Project	IEEE 802.16 Broadband Wireless Access Working Group < http://ieee802.org/16 >	
Title	Proposed Updates to Handoff Section in Draft IEEE 802.16m Evaluation Methodology Document	
Date Submitted	2007-05-03	
Source(s)	Hyunjeong Hannah Lee Ali Koc Roshni Srinivasan Sassan Ahmadi Intel Corporation	hyunjeong.hannah.lee@intel.com ali.t.koc@intel.com roshni.m.srinivasan@intel.com sassan.ahmadi@intel.com
Re:	IEEE 802.16m-07/014r1– Call for Comments on Draft 802.16m Evaluation Methodology Document	
Abstract	This document contains proposed text for the draft evaluation methodology for IEEE 802.16m technical proposals.	
Purpose	For discussion and approval by TGm	
Notice	This document has been prepared to assist IEEE 802.16. It is offered as a basis for discussion and is not binding on the contributing individual(s) or organization(s). The material in this document is subject to change in form and content after further study. The contributor(s) reserve(s) the right to add, amend or withdraw material contained herein.

Figure 9.1.1.1-1: Trajectory 1

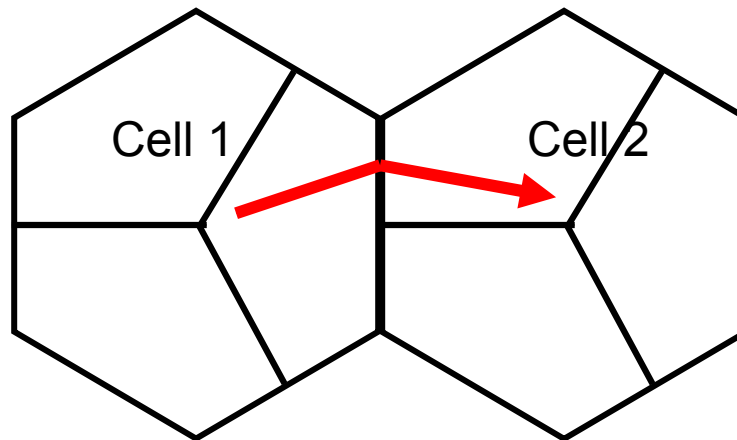
In order to maintain consistency with the antenna orientation defined in Figure 22.2-2, the following text in section 9.1.1. is proposed to replace the text in section 39.1.1. of IEEE C802.16m-07/080r1.

9In this trajectory, the MS moves from Cell 1 to Cell 2 along the arrow shown in Figure
109.1.1.1-1. The trajectory starts from the center of Cell 1 to the center of Cell 2 while
11passing through the midpoint of the sector boundaries as shown in Figure 9.1.1.1-1.
12The purpose of this trajectory is to evaluate handover performance in a scenario where
13the signal strength from the serving sector continuously decreases whereas the signal
14strength from the target sector continuously increases.

Figure 9.1.3-4: 7 Cell Topology

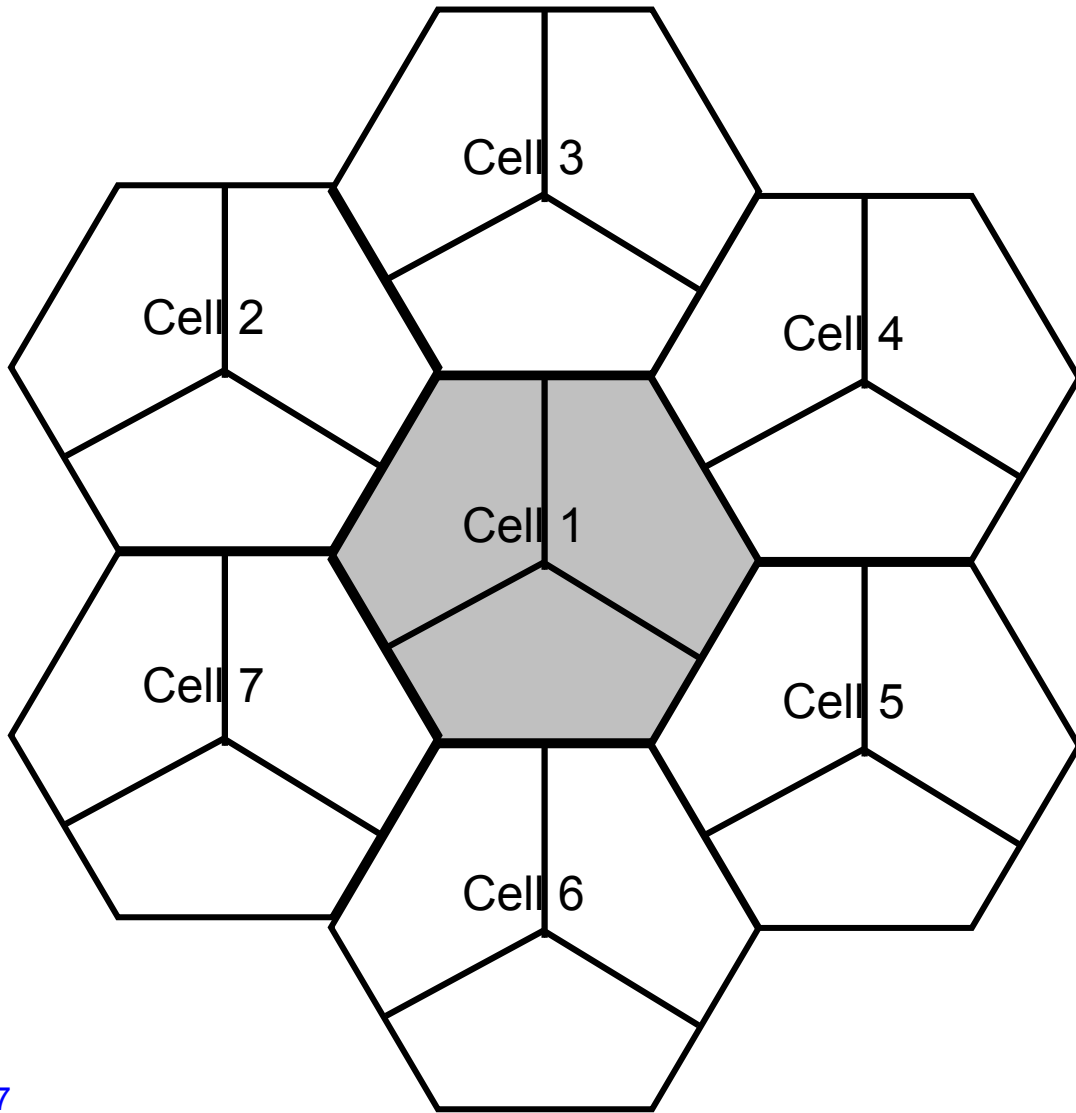
In order to maintain consistency with the antenna orientation defined in Figure 22.2-2, Figure 9.1.3-4, is proposed to replace the figure 9.1.3-1 in section 9.1.3. of 3IEEE C802.16m-07/080r1.
